寄件者: [REDACTED]
寄件日期: 2025年08月14日星期四 14:07
收件者: tpbpd/PLAND
副本: [REDACTED]
主旨: Re: S. 16 Planning Application No. A/YL-KTN/1113 - Departmental Comments
附件: AYL-KTN 1113 20250814.pdf

Application No. A/YL-KTN/1113
Lots 949 (Part) and 1103 (Part) in D.D. 107,
Kam Tin North, Yuen Long, New
Territories

Drainage Proposal

Response to Comment Table

Figure 2.3 – Discharge Path for Stormwater collected within the Project Site

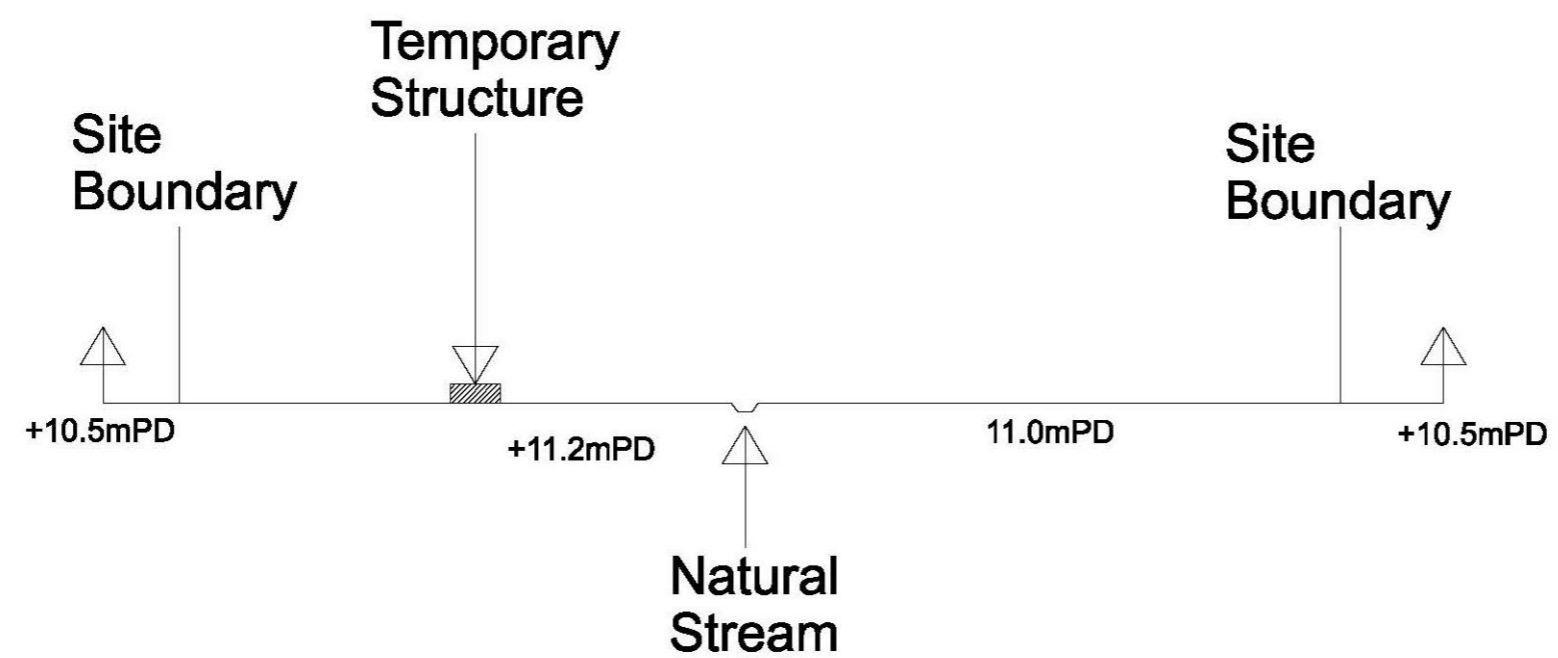
<p>(e) Figure 2.3 – More cross sections should be provided. The proposed/ existing drains should also be shown on sections. The sections should extend further to show the flow direction of the adjacent sites.</p> <p>(f) Figure 2.4 – For photo 1, please provide and indicate in the report that adequate opening should be provided to intercept the existing overland flow passing through the site.</p> <p>(g) Figure 2.4 – For photo 3, please clarify how the overland flow could pass through the site as there is concrete footing along the hoarding.</p> <p>(h) Figure 2.5 – Photo 2, please advise the size of underground pipe. Please provide evidence (such as CCTV record) to show the internal condition of existing pipe is acceptable. The alignment and details of the pipe should show on drainage layout plan as well.</p> <p>(i) Figure 2.6 – All existing drainage network and details should be indicated on drainage plan.</p> <p>(j) Figure 2.6 – Photo 3, please provide more details of the concerned drains as there is no drainage related item shown in the photo.</p>	<p>Noted. Additional cross sections have been added to Figure 2.3.</p> <p>Noted. Section 4.3.2 has been added to discuss the provision of U-Channel to intercept the overland flow entering the Project Site.</p> <p>Noted. Section 2.2.4 has been updated to discuss how the stormwater being directed into the centre of the project Site. Figure 2.6 has been added accordingly.</p> <p>Please note the pipe will be removed and upgraded in the proposed drainage arrangement. Section 4.3.4 has been revised to discussed the upgrade accordingly.</p> <p>The existing drainage network has been given in Figure 2.2.</p> <p>As the existing drainage system will not be retained after the works, no details of the existing drainage channels is available. The existing drainage network is given in Figure 2.2 for reference.</p>

Noted. **Figure 2.3** has been added to show the flow path from the natural stream towards the ultimate discharge point. As some of the area is private area, aerial photos is provided.

Figure 3.1 – Identified Catchment Area

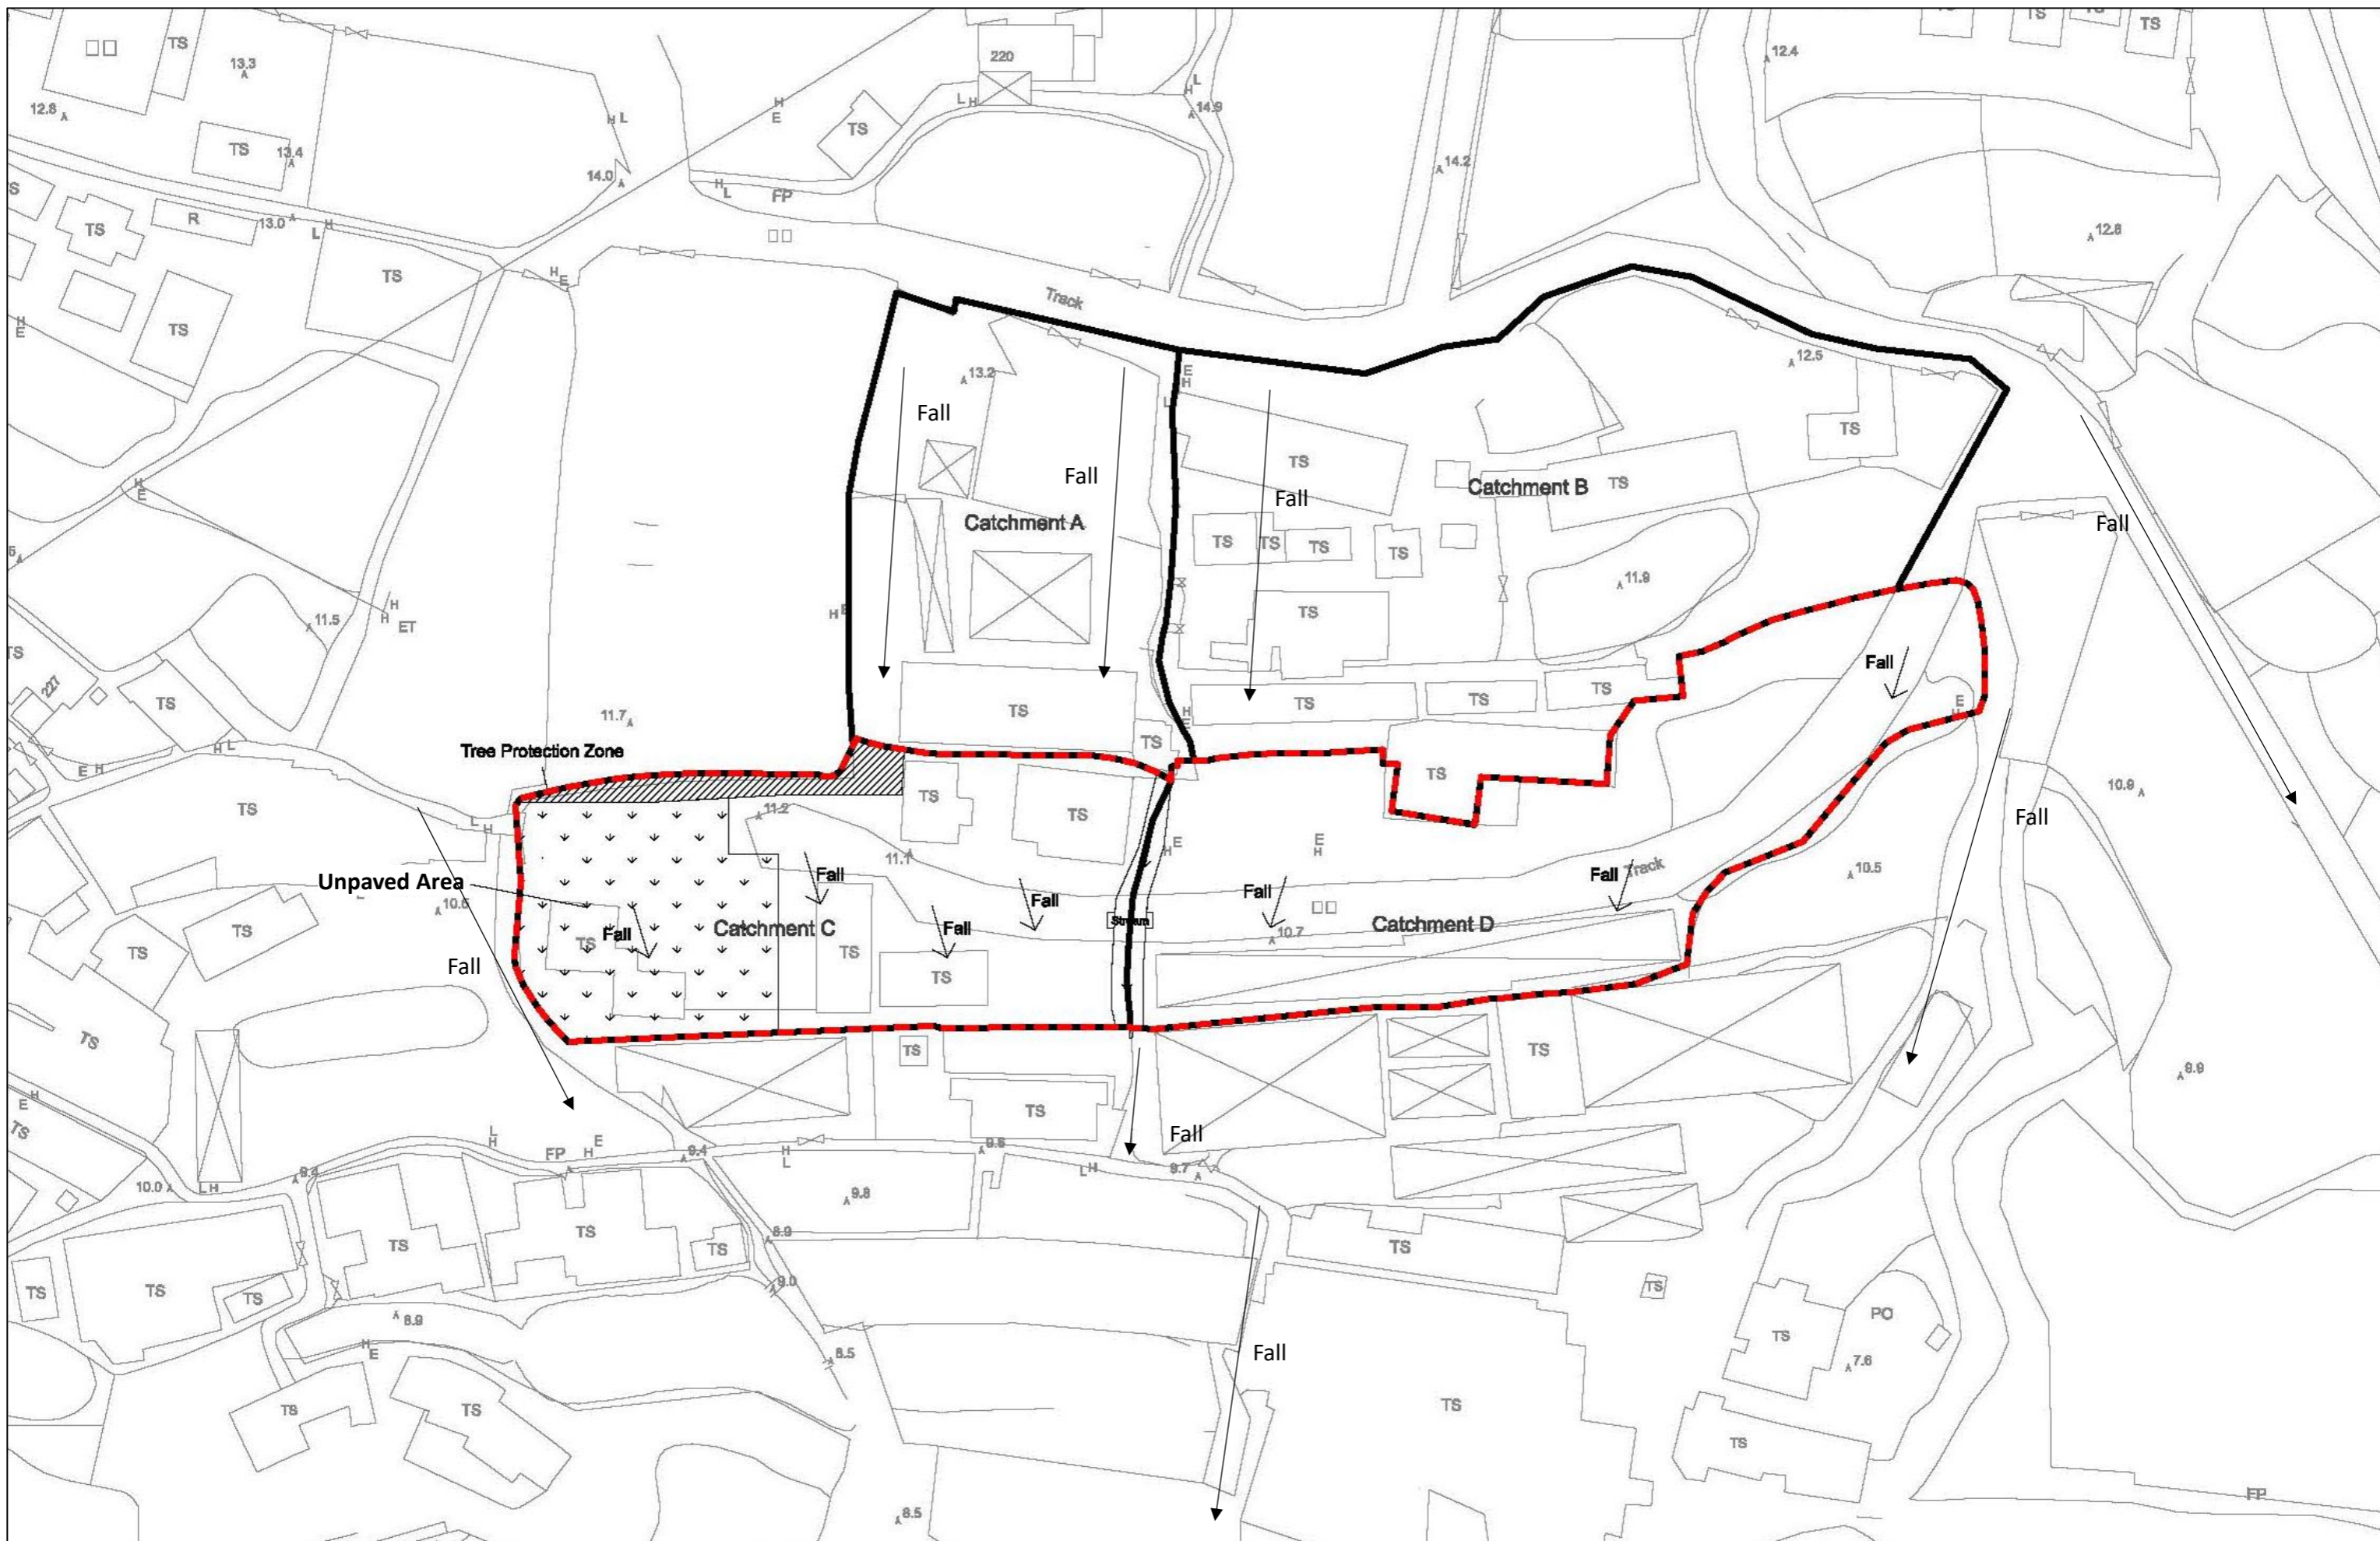
<p>(k) Figure 3.1 – Please provide photo record to show the grassland area, as it cannot be identified in the aerial photo in Figure 2.8.</p> <p>(l) Figure 3.1 – Flow direction of the catchment areas and adjacent sites should be indicated.</p> <p>(m) Figure 4.2 – Size and gradient of all proposed and existing drains should be shown on drainage plan for easy reference.</p> <p>(n) Figure 4.2 – All proposed discharge points should be clearly indicated on drainage plan.</p> <p>(o) Appendix 4.2 – Runoff coefficient of unpaved area is considered underestimated. Please justify the land characteristic as appropriate.</p> <p>(p) Appendix 4.4 – Please clarify which natural stream refers to. Please clarify what is mid-point and discharge point refer to. You are suggested to elaborate with showing more details in the drainage plan. Again, the most conservative section of the path should be adopted for assessment.</p> <p>(q) R-to-C table – Please review the comment received date which should not be in 2017.</p>	<p>Noted. The “Grassland” is the unpaved area used for cattle keeping. Photo 2.4+ has been added to show the grassland area. Section 3.2.4 has been updated accordingly.</p> <p>Additional fall directions have been added to Figure 3.1.</p> <p>Noted. Figure 4.2 has been updated accordingly.</p> <p>Noted. Figure 4.2 has been updated accordingly.</p> <p>The area is considered sandy soil as shown in Figure 2.6. For more conservative assessment, 0.15 was used for the runoff coefficient of the unpaved area. Appendix 4.2 has been updated accordingly.</p> <p>Noted. The natural stream refers to the stream at the centre of the Project Site. The wordings have been updated accordingly.</p> <p>Noted. The typo has been updated accordingly.</p>

Figure 4.2 – Proposed Layout of the Drainage Channel for the Project Site

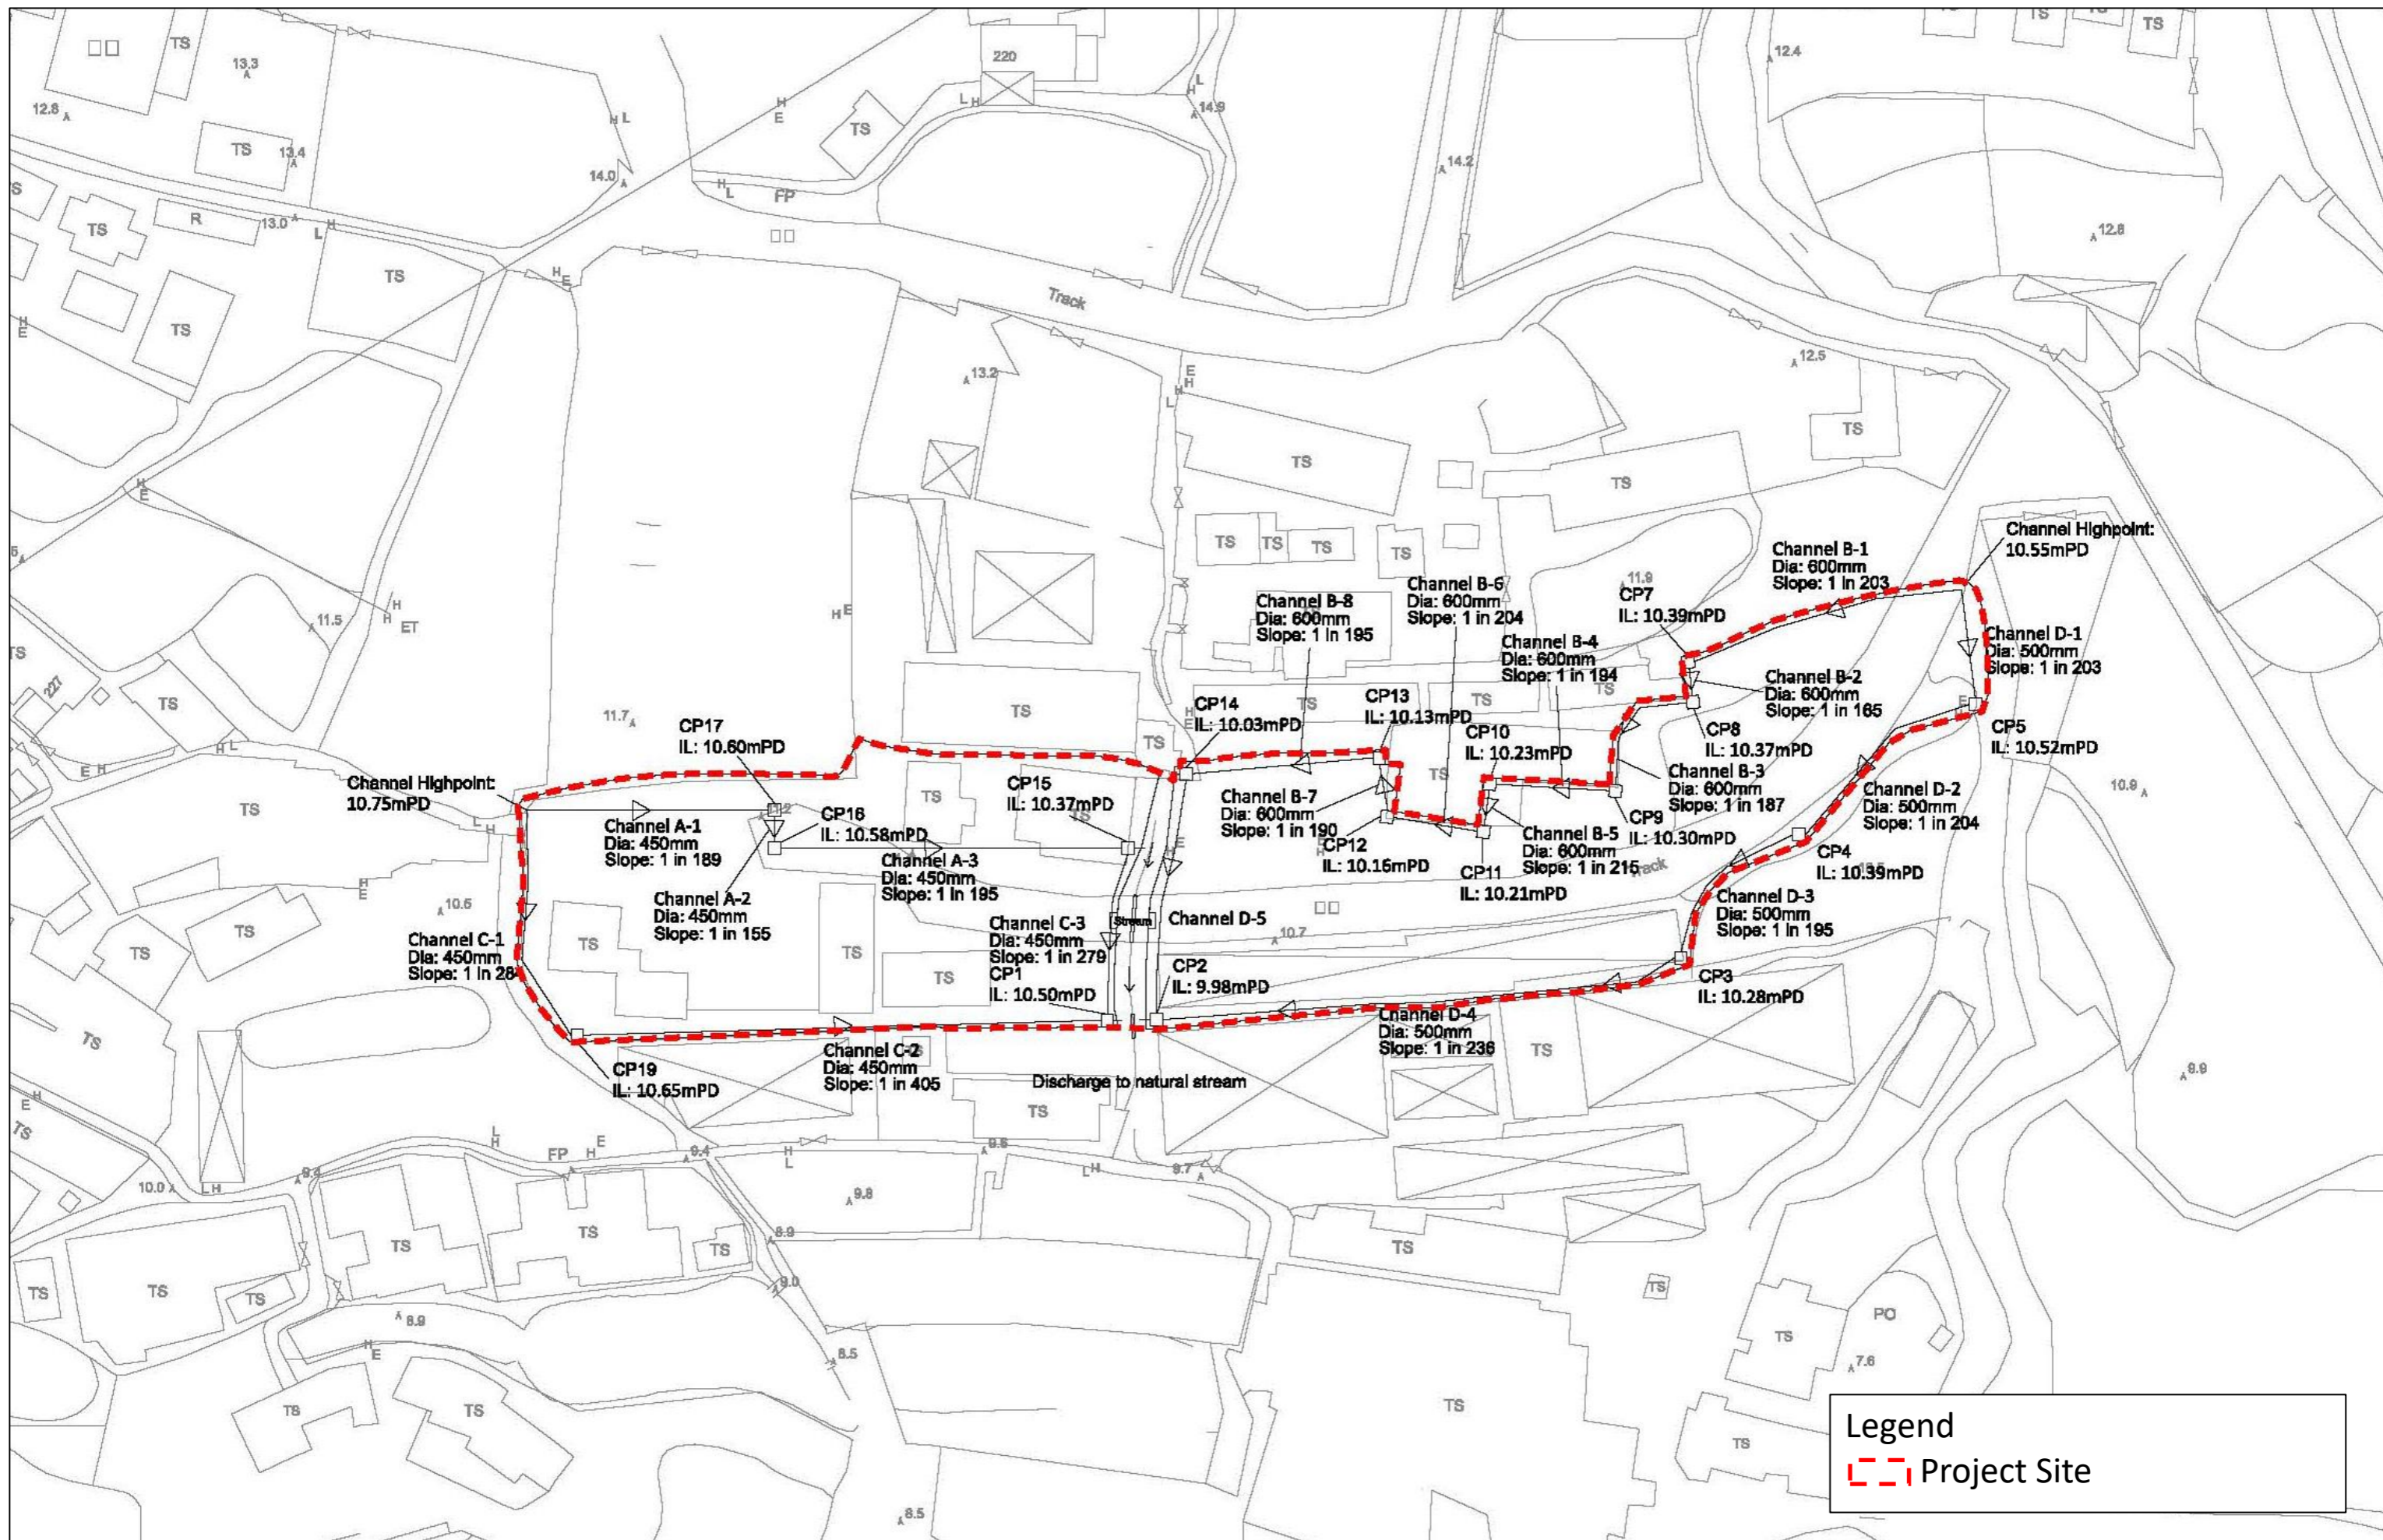
3. Figure 4.1 - Channel size and gradient should be shown on drawing.	Noted. The information has been included in Figure 4.2 .
4. Figure 4.1 - All proposed discharge points (with size and gradient) should be clearly indicated on drawing.	Noted. The information has been included in Figure 4.2 .

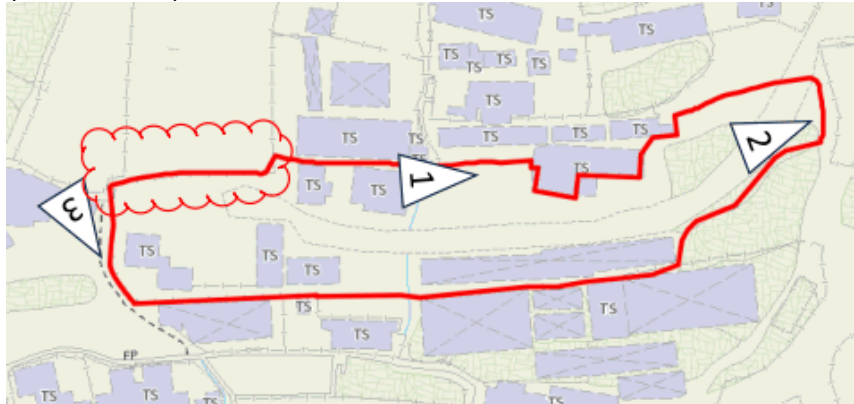
(t) R-to-C (x) – Please provide photo record for the general view of northwest area outside application site for reference (as clouded).

Noted. Aerial photos are given in **Figure 2.6**. Please note the area is not accessible on ground.
